Responses to Ballinrooaun Quarry Extension – items 2, 5, 6, 7 and 11

Figure 1 Typical section through temporary upper part of restored/filled slope

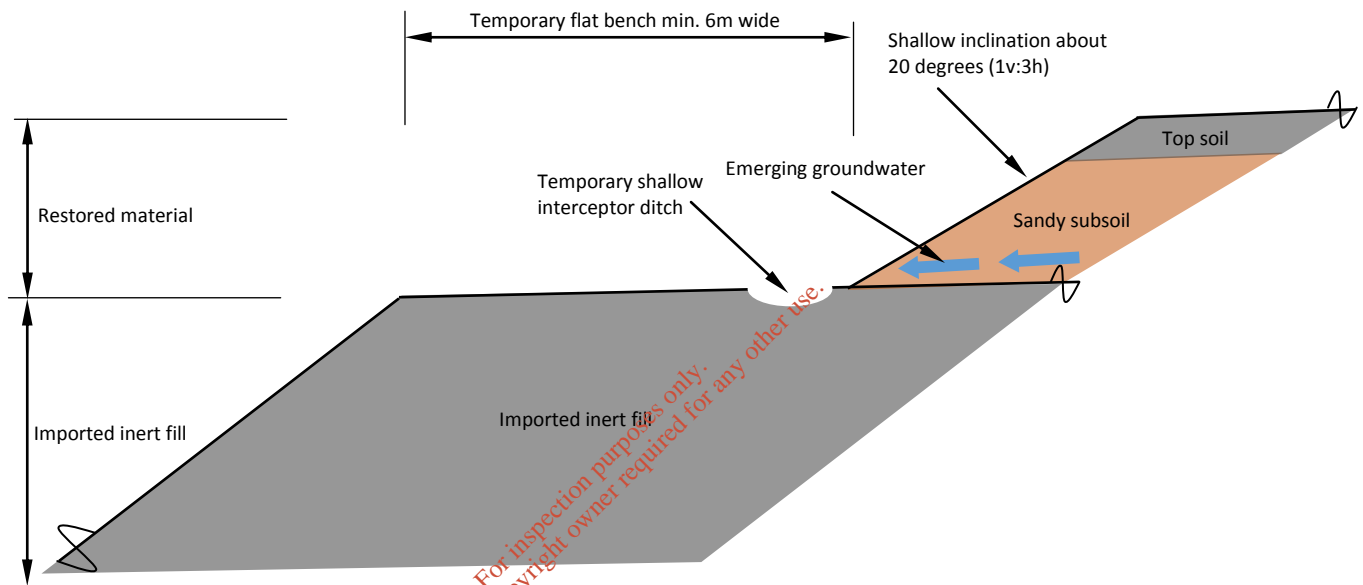
5. *The EIAR as submitted includes insufficient detail on the material to be imported for the restoration of the landform. The EIAR should be amended to include for more detailed assessment, mitigation and specification on the type of material to be imported and used in the restoration of the quarry. The EIAR shall also sufficiently demonstrate or model how soil erosion or slippage will be avoided where the less permeable infill material meets the retain sandy overburden upon completion of restoration.*

- (a) More detailed assessment on type of material to be imported and used in the restoration of the quarry, and
- (b) Avoidance of soil erosion or slippage where the less permeable infill material meets the retain sandy overburden upon completion of restoration.

In the temporary condition it would be necessary to control water emerging from the interface of the sandy subsoil and inert fill, as such the following measures are to be included, also see Figure 1:

- (i) A temporary flat bench is to be left at the upper surface of the inert fill between the inert fill slope and the area of the restored quarry (that is where the sandy subsoil and topsoil have been placed). Bench width to be at least 6m wide to allow access for machinery.
- (ii) A temporary shallow interceptor ditch is to be constructed on the flat bench at the base of the sandy subsoil slope to intercept emerging water and channel it to the edge of the filling area and into the quarry floor.
- (iii) The front face of the restored sandy subsoil slope, which is temporary, shall be at a shallow inclination of about 20 degrees (1v:3h) or less to avoid slumping of slope.
